Proposal to Modify the ISI Penalty calculation in the current GbE Spreadsheet Model

David Dolfi
Agilent Technologies
April 6, 2000

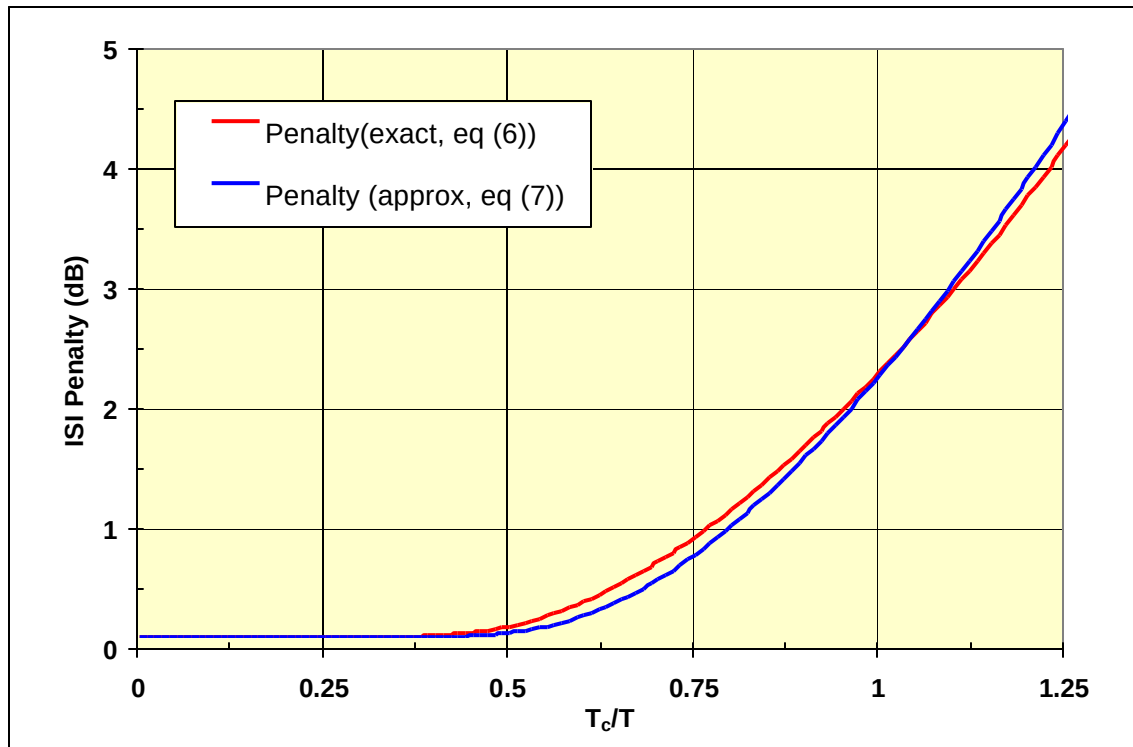
The difference between (6) and (7) can be seen on the graph below, where both equations are graphed in dB according to (8) as a function of (T_c/T) . For small values of this parameter, corresponding to a rapid system risetime relative to the baud period, the approximation (7) is slightly smaller than the expression (6), underestimating the ISI penalty. However, as the system risetime grows relative to the baud period, particularly in the region where the ISI penalty is > 3 dB, the approximation (7) is larger than (6), overestimating the ISI penalty by a non-negligible amount (several tenths of a dB). Since this is precisely the region in which the ISI penalty becomes critical, I would propose using the expression (6) in the spreadsheet rather than the approximation (7) to it.
